RECEIPT DATE: 5/12/15 **ONSITE SEWAGE DISPOSAL SYSTEM** P 556457

PROPERTY ADDRESS: 2508 Goose Chase Way

RE: BAT Site Plan comments; 2508 Goose Chase Way (Cloverfield II, Lot 7)

SITE PLAN AND PLOT PLAN FOR BAT INSTALLATION
SPRING MILL LLC
2508 GOOSE CHASE WAY
TAX ACCOUNT NO.: 353427
LOT 7
CLOVERFIELD- SECTION II
3RD ELECTION DISTRICT • HOWARD COUNTY, MD.
TAX MAP: 15 BLOCK: 7 PARCEL: 119

GENERAL NOTES

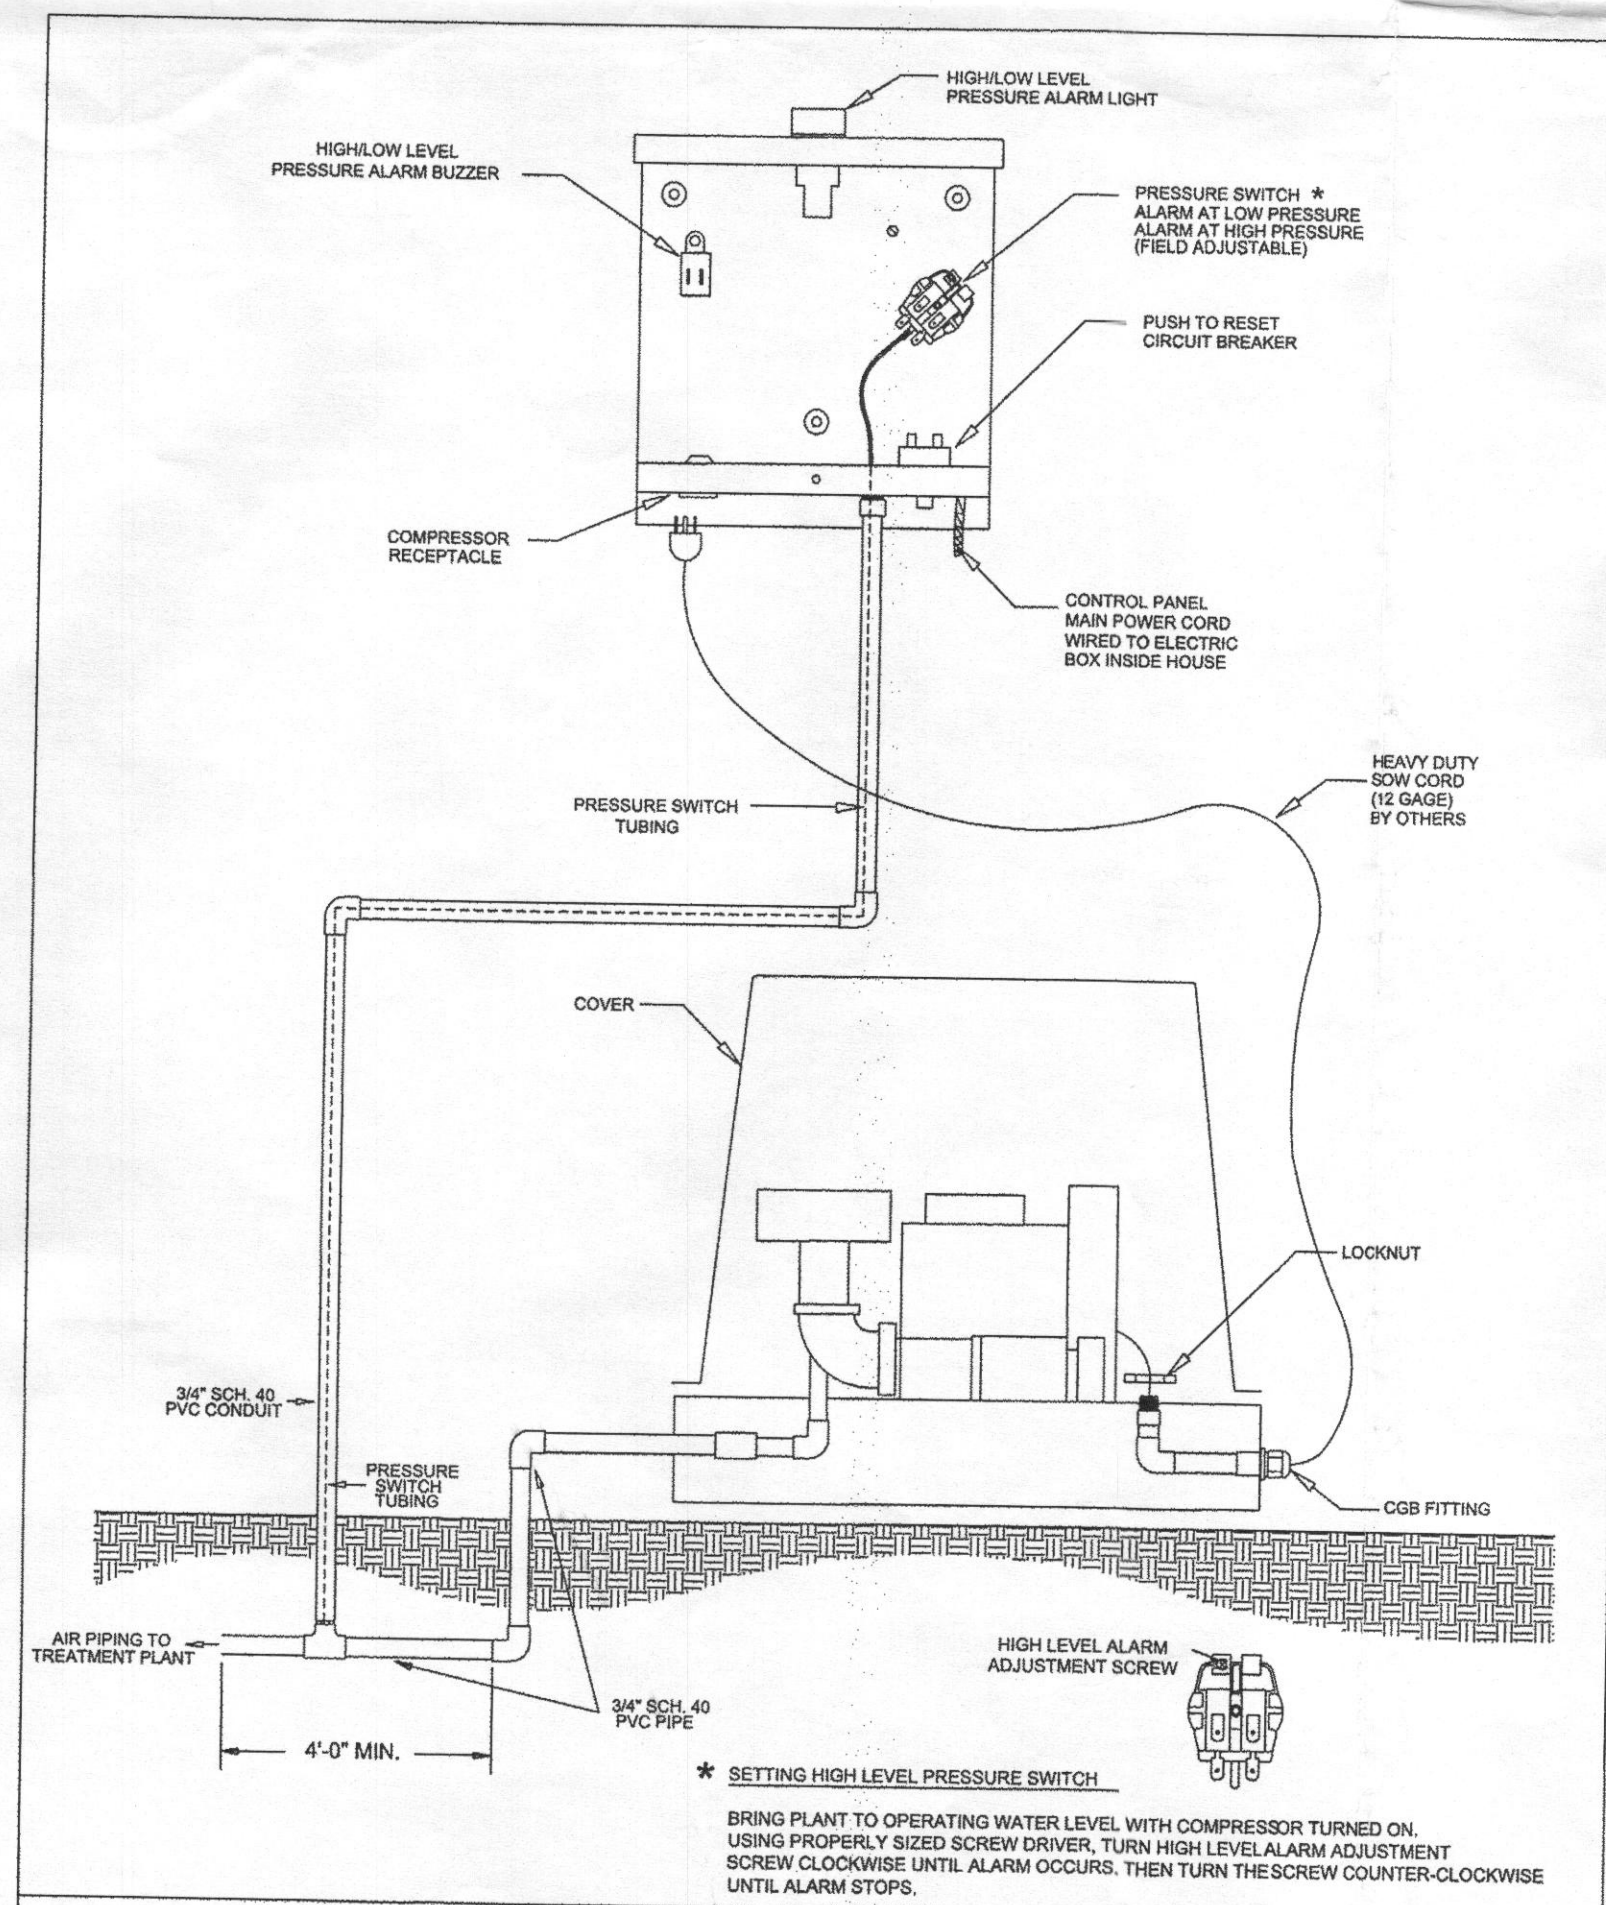
Revisions are needed on the submitted BAT Plan (March 26) for the subject property.

The required revisions are the same as those items which were red-lined on February 6, on the plan proposing an ECOPOD installation. See the three (3) pages attached which are photocopies of the portions of the plan red-lined on February 6.

1. The well configuration on the referenced Percolation Certification Plan (October 2007) is a well zone. The configuration of three well locations illustrated on this submittal is not approvable without a revised Percolation Certification Plan.
2. The areaway is considered part of the foundation, therefore the BAT unit must be at least 20 feet from the areaway.
3. The distribution lines are spanning a concave landform, and your placement of trenches utilizes the sewage disposal area in a very inefficient manner. The best option to mitigate these issues is to place a distribution box at the uppermost boundary of the sewage disposal area and illustrate equal length lines to each side of the swale.
 - a. Limit the trench bottom to 5.5 feet. (Please notice that this reduces your coefficient for trench length reduction = 0.5)
 - b. Utilize 42-foot trenches to either side of the D-Box

1. The plan has been revised per the attached red lines.
